Addendum No. 1

COS 2017 UNIT 3 WATER MAIN REPLACEMENT PROJECT

PWP Bid No. WA-2017-126
March 15, 2017

SHEET NUMBER
P4
 8 OF 27

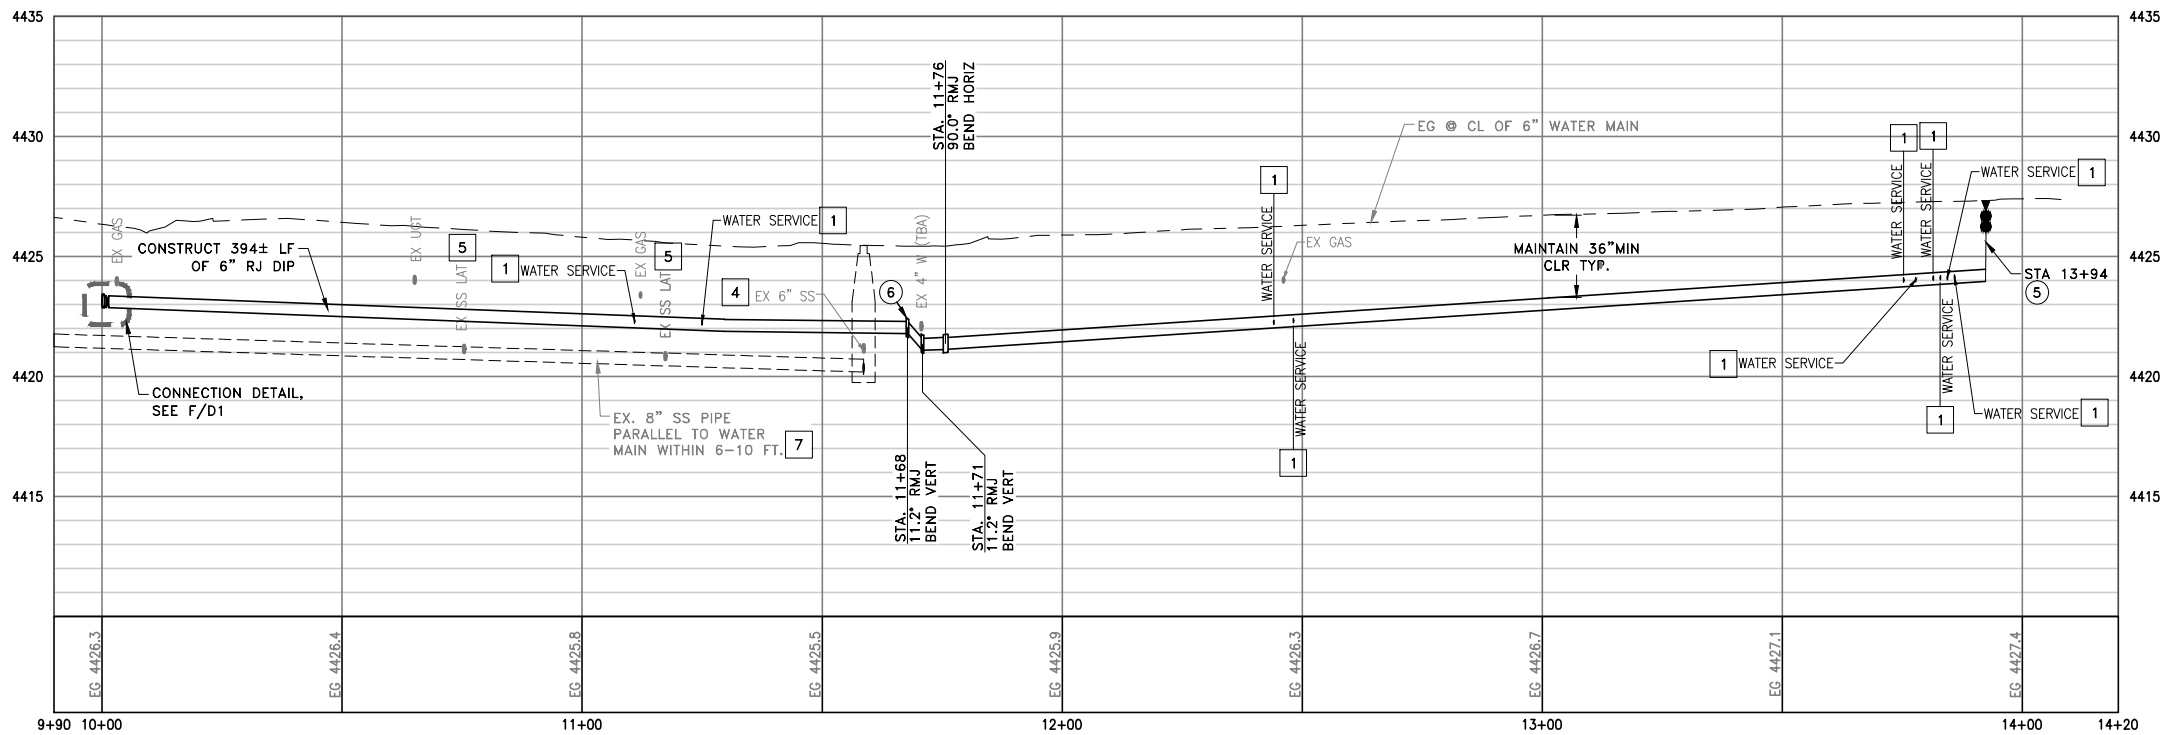
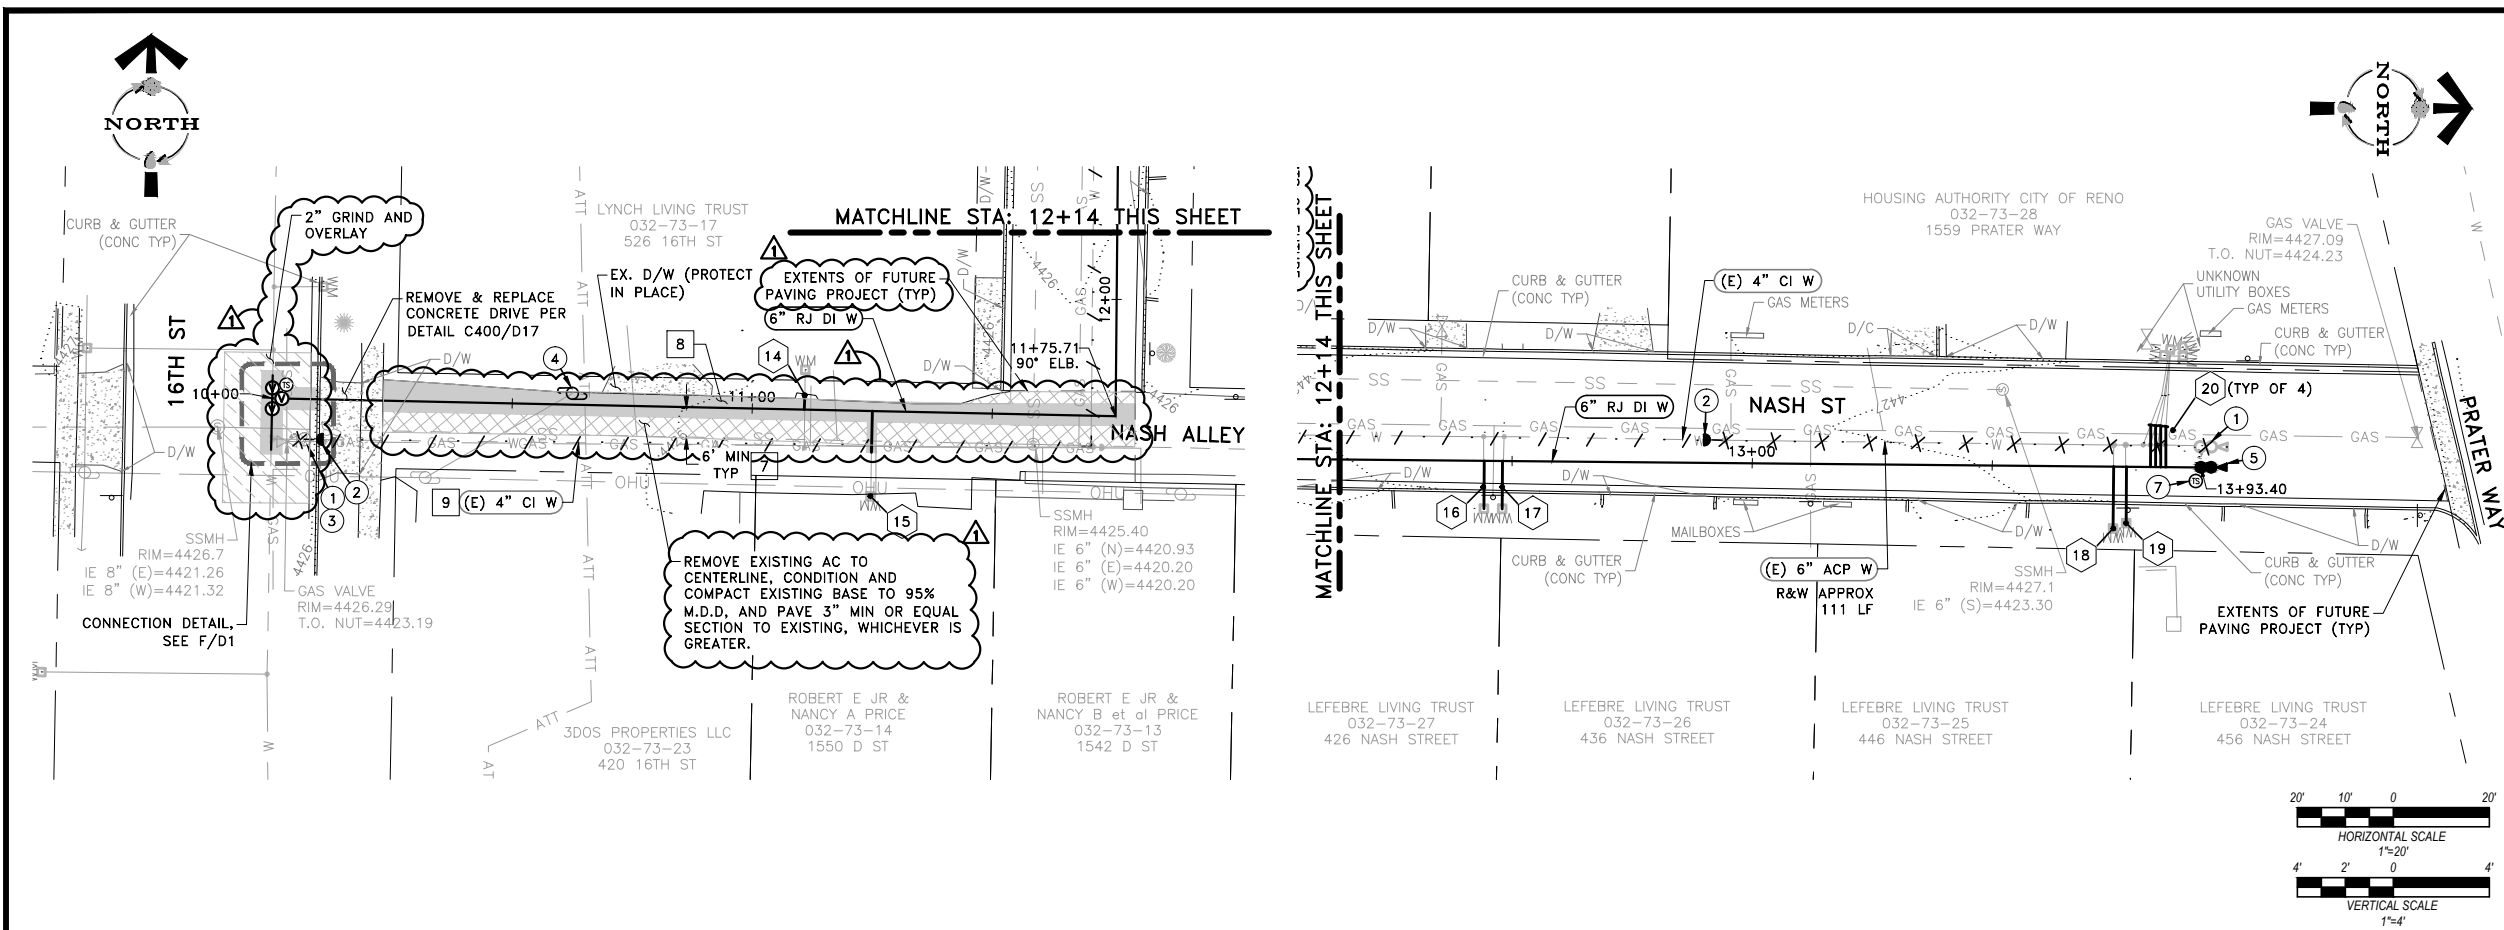
- **REPLACE DRAWING SHEET P4 WITH THE ATTACHED –**
Added 2" grind and overlay hatch to the centerline of 16th street. Remove existing AC to centerline of Nash Alley; condition and compact existing base to 95% Maximum Dry Density, and pave 3" min or equal section to existing AC, whichever is greater. Move limits of future paving project line and extended permanent pavement patch in to the intersection of Nash and the Nash Alley. Changed the existing material callout for water service #15 from plastic to copper. Due to the material change the service no longer needs full replacement to the meter.

CONCRETE DRIVEWAY (NASH ALLEY)
NTS

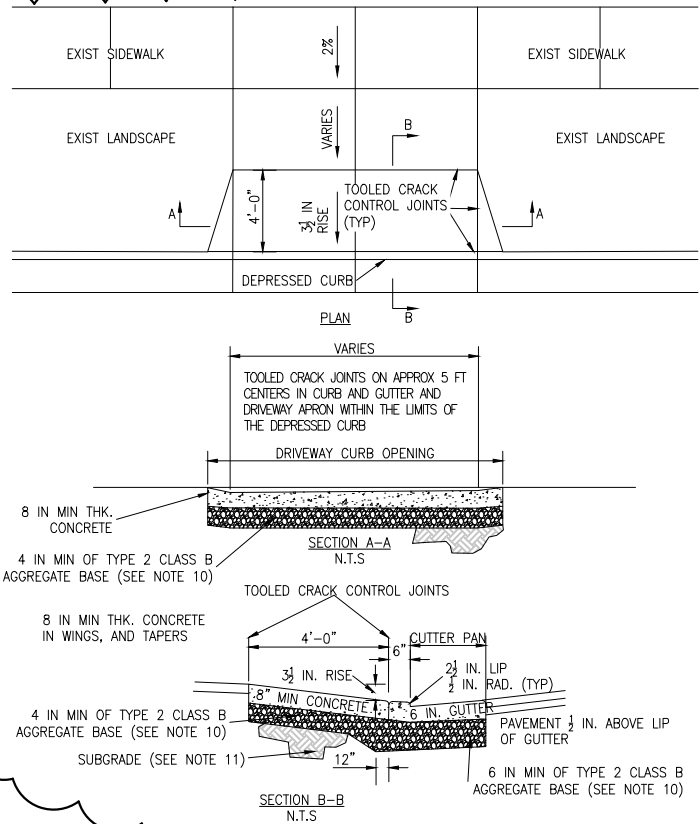
- **REPLACE DRAWING SHEET D17 WITH THE ATTACHED**
Removed and Replaced C400/D17 with a standard driveway detail for Nash Alley and 16th street.
